# Aqua Lung America **TECHNICAL BULLETIN**

Mar 22, 2010  
No. 29

**SUBJECT: Recall Notice of the Apeks WTX Inflator.**

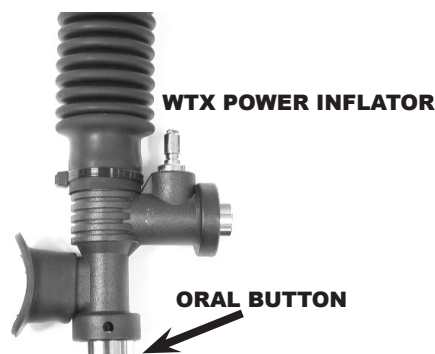
**PROBLEM:** Aqua Lung has been made aware of a case of a poorly retained oral inflate button that came off of an Apeks WTX inflator. If the button were to come off, the spring behind the button would also come off thereby removing the tension needed to keep the valve closed. If this were to occur in the water, it could lead to a leak of the BC contents out of the oral mouthpiece.

The button is supposed to be adhered with a high-strength thread locker. Our research into the matter indicates that some units may have been improperly adhered by our supplier. Because an inspection of the button is easy to do, Aqua Lung believes that it is prudent to inspect all units in the field. We believe that very few, if any, of the WTX inflators will exhibit this problem.

**INSPECTION:** Inspection consists of immobilizing the oral shaft while trying to spin off the oral button by hand. If the button does not spin off, then it is unaffected and is considered safe to continue using.

**CORRECTIVE ACTION:** Should the button spin off by hand, then it needs to be properly fastened using a high-strength thread locker.
